To: All Interested Bidders and Plan Holders
From: Jennifer Steed, Senior Project Manager
RE: Lake Myra County Park Phase 1 (RFB#26-077)
Addendum No. 3
Date: September 29, 2026

1. See attached current plan holders list.
2. See attached Revised Bid Proposal Form.
3. See attached new and reclaimed playground equipment lists.
4. See attached Addendum No. 3 (including revised sheets) from Esse Architects.

301 2x6 TONGUE AND GROOVE WOOD DECKING WITH 9/16" PLYWOOD.

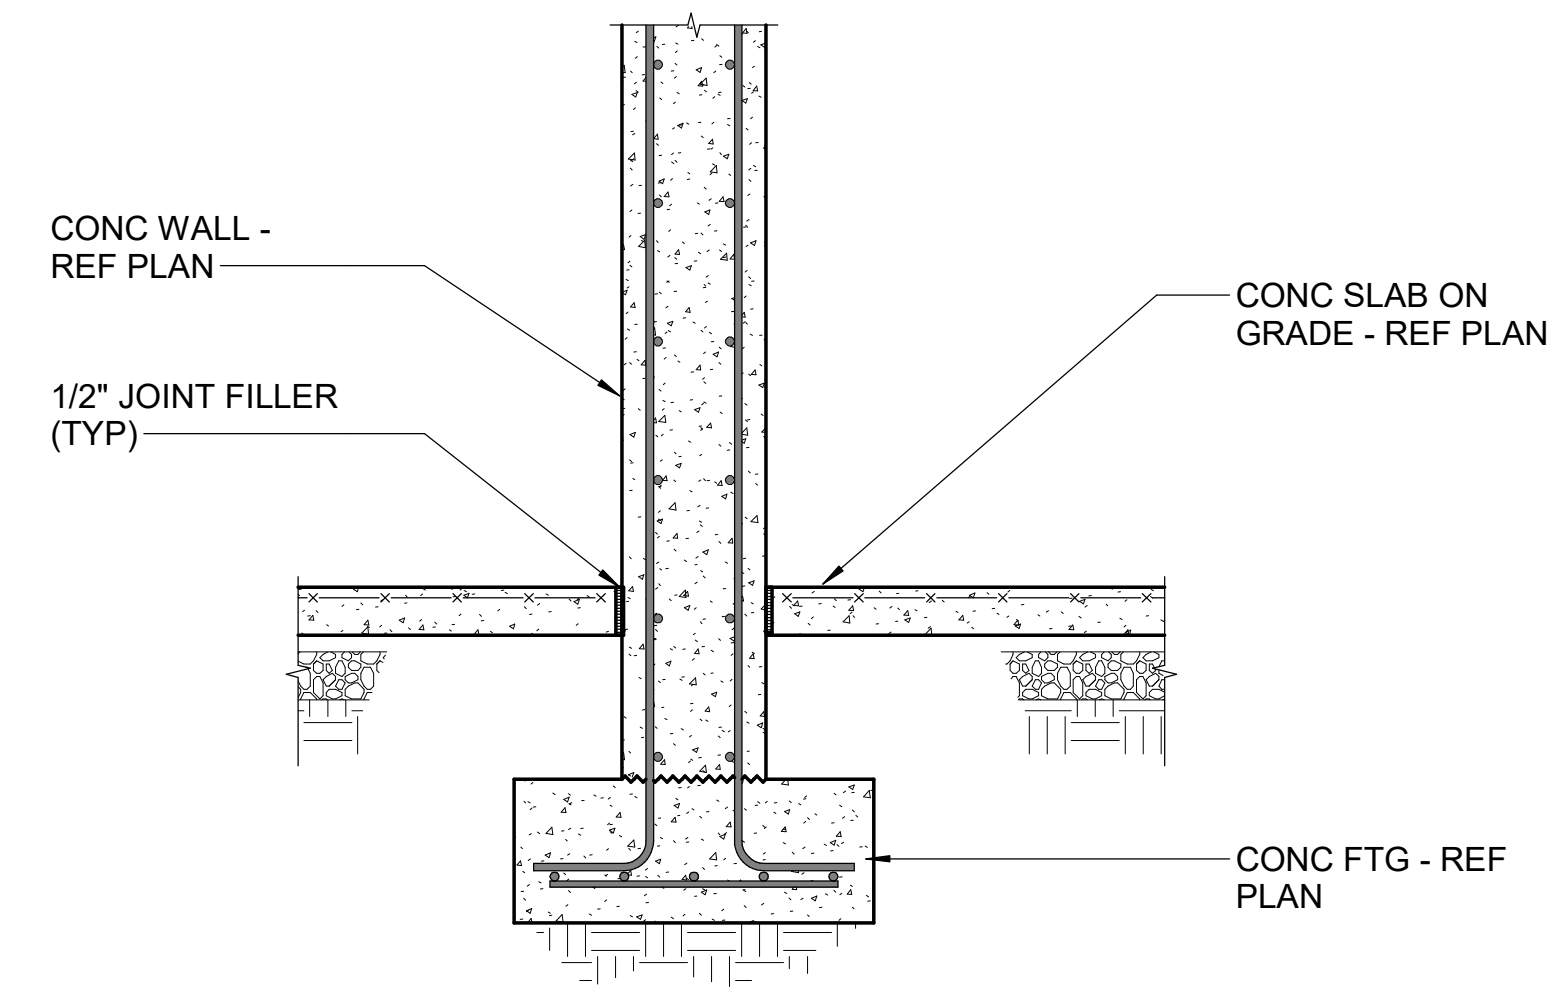
11. Bidder Question: Architectural details call for 2x4 T&G roof decking however structural drawings call out 2x6. Which is correct?

a. **Response: All structural roof deck to be 2x6 T&G**

PC-S304

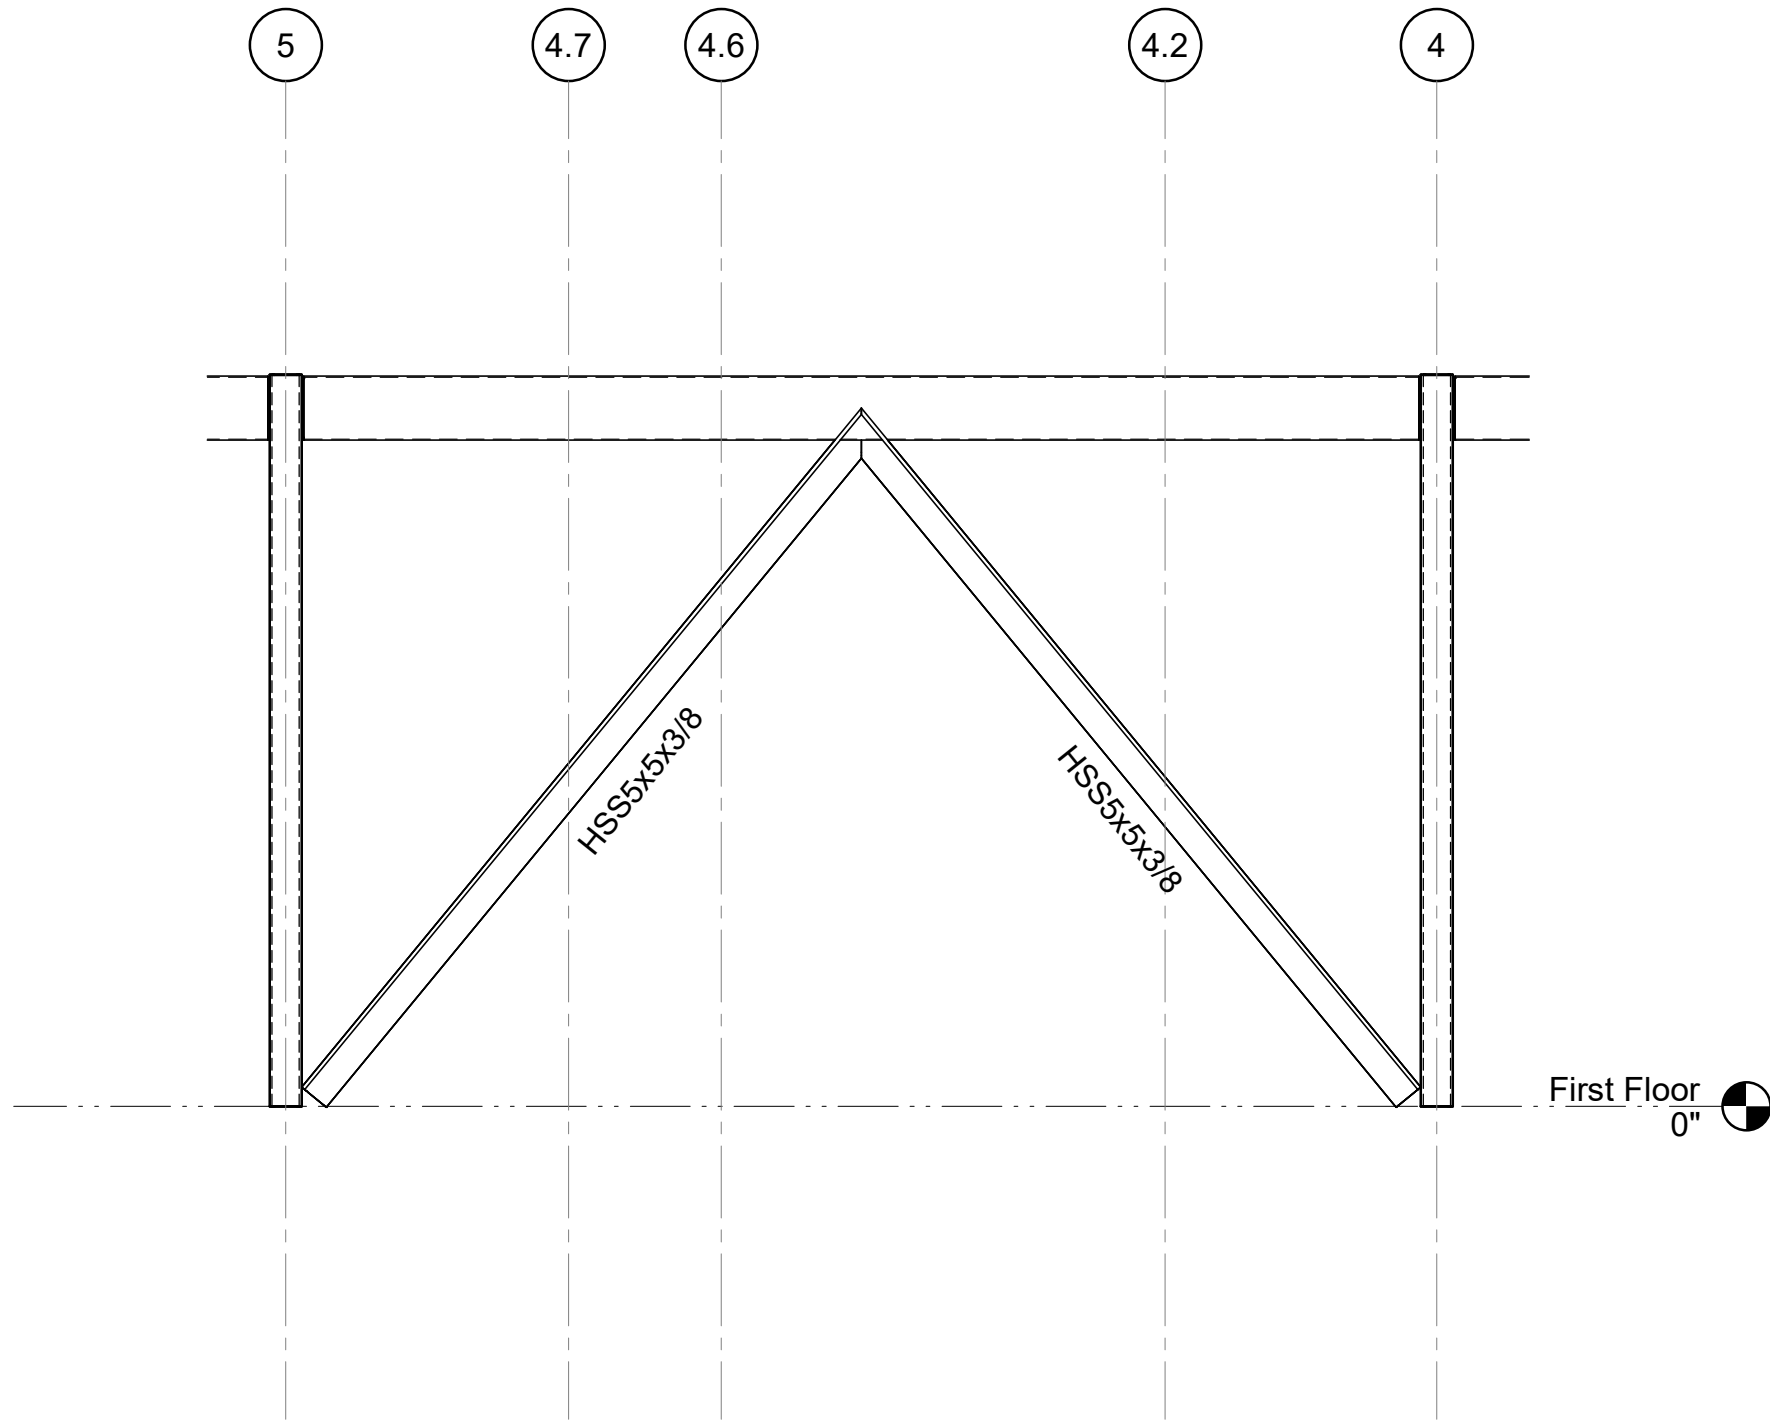
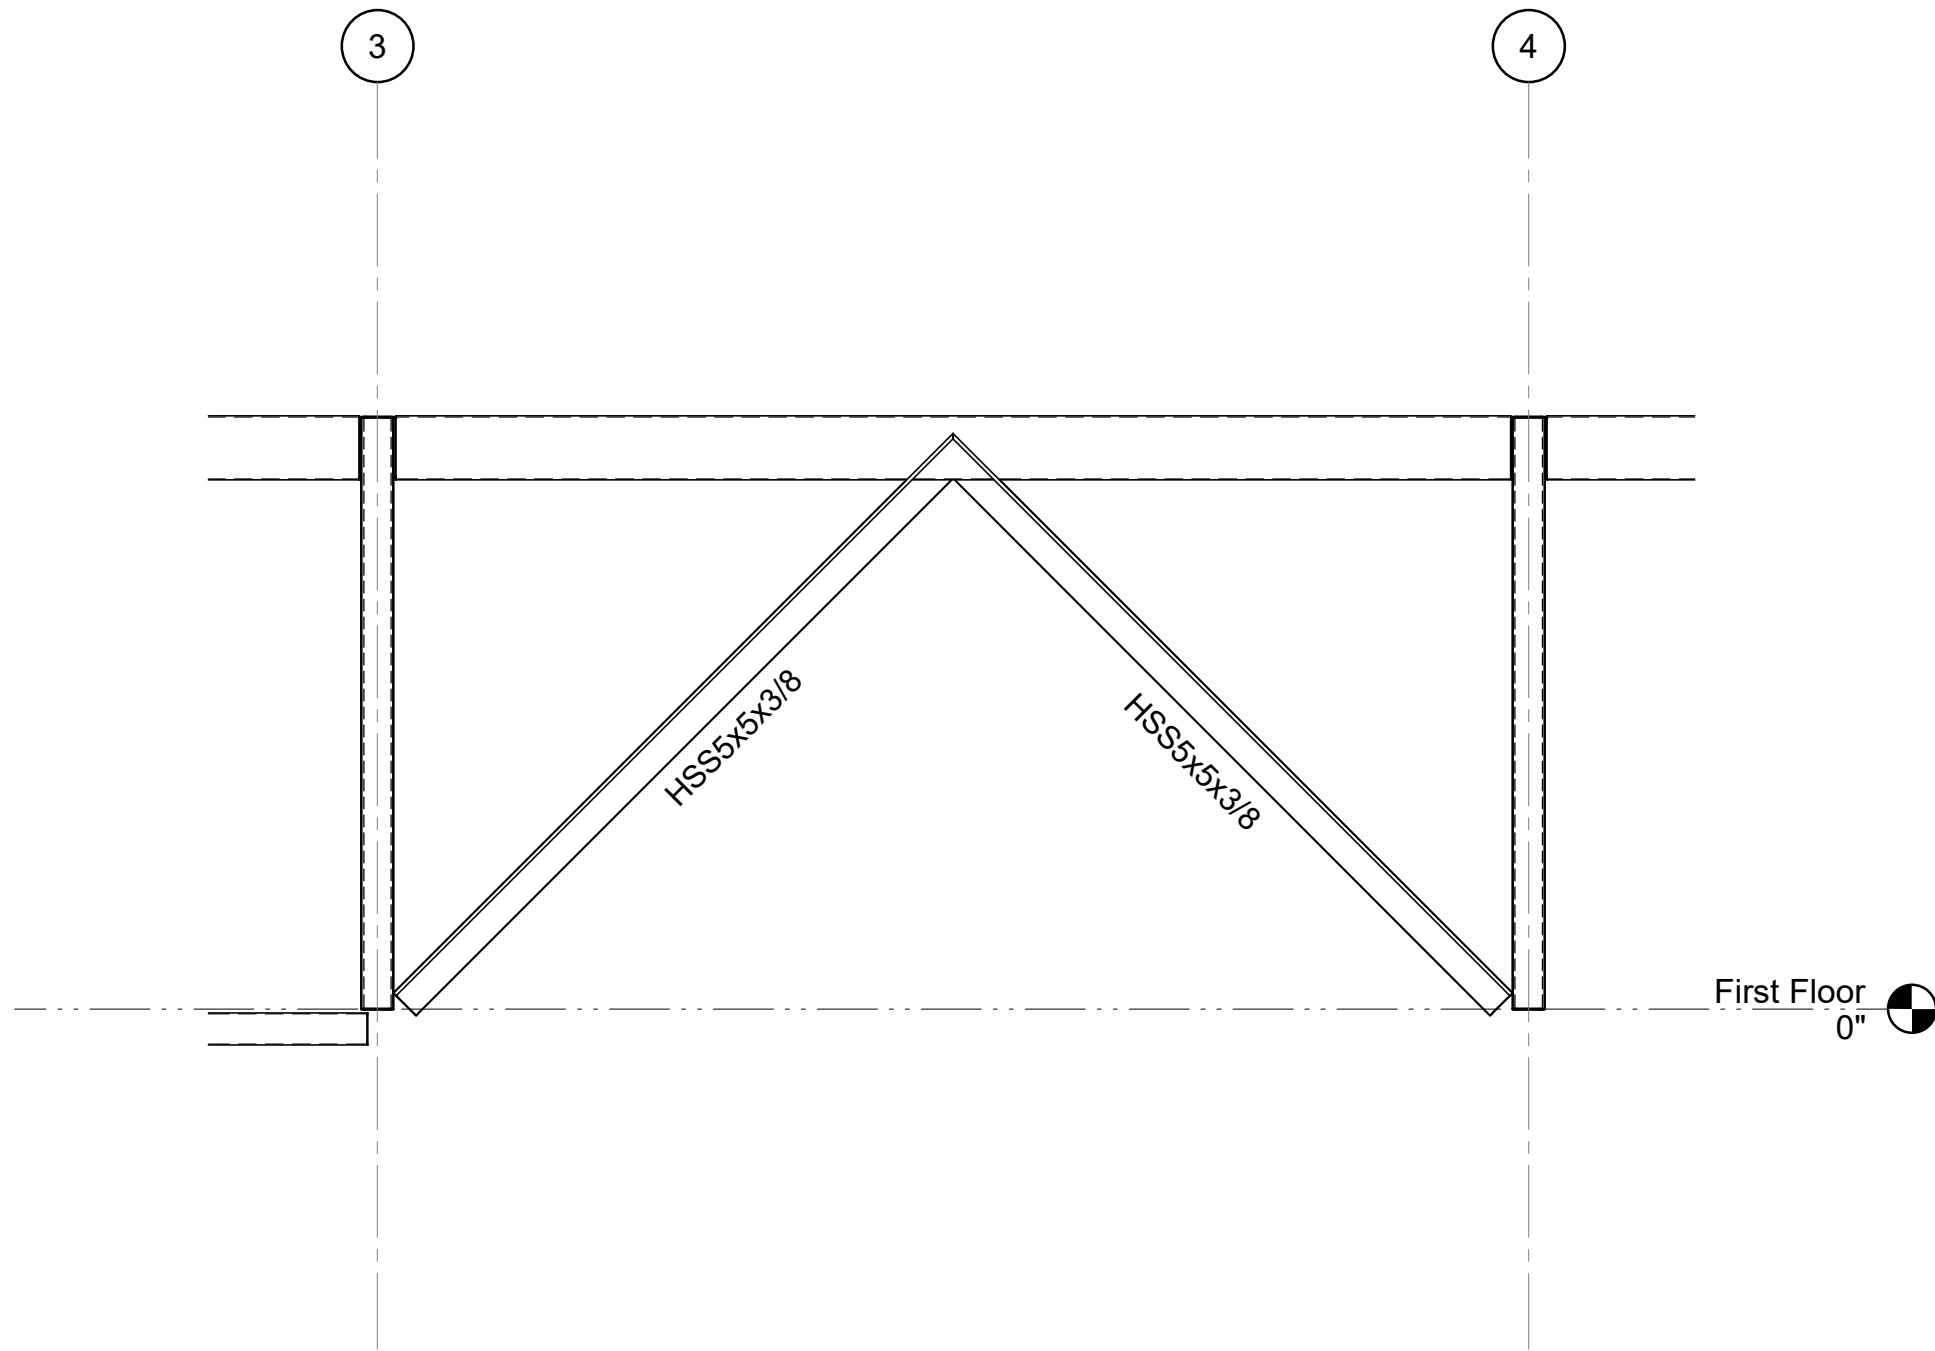
12. The Park Center structural drawings reference a PC-S304 drawing. Can this drawing be provided?

a. **Response: See addendum #3 for PC-S304**
